# Supro Model S-6606

Sluckey 04/30/2021

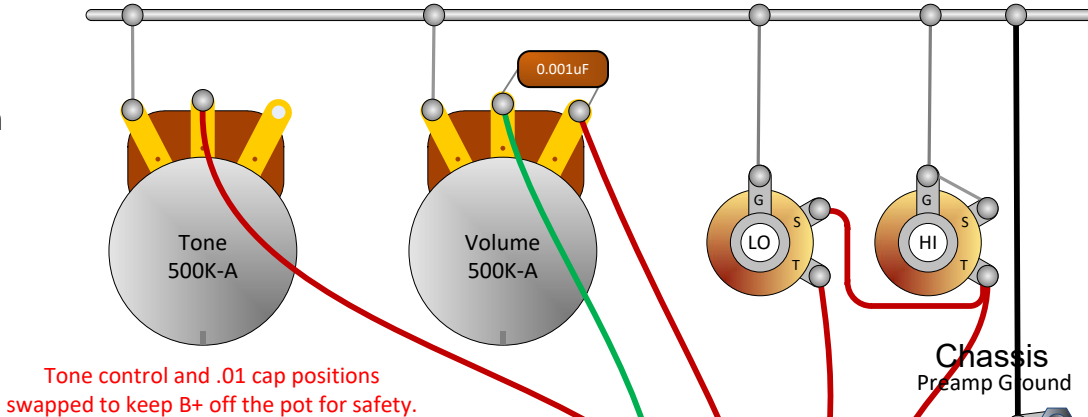
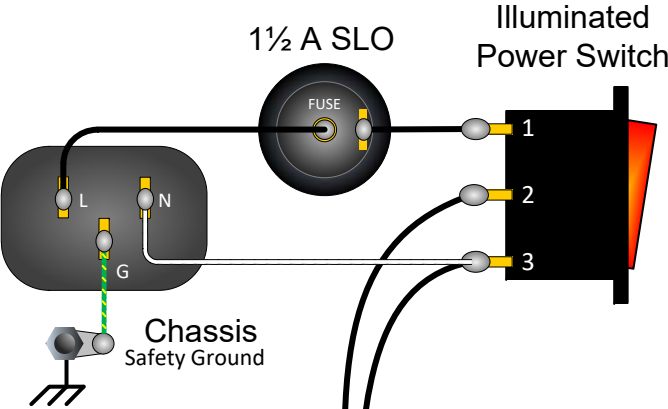
Tone control and .01 cap positions swapped to keep B+ off the pot for safety.
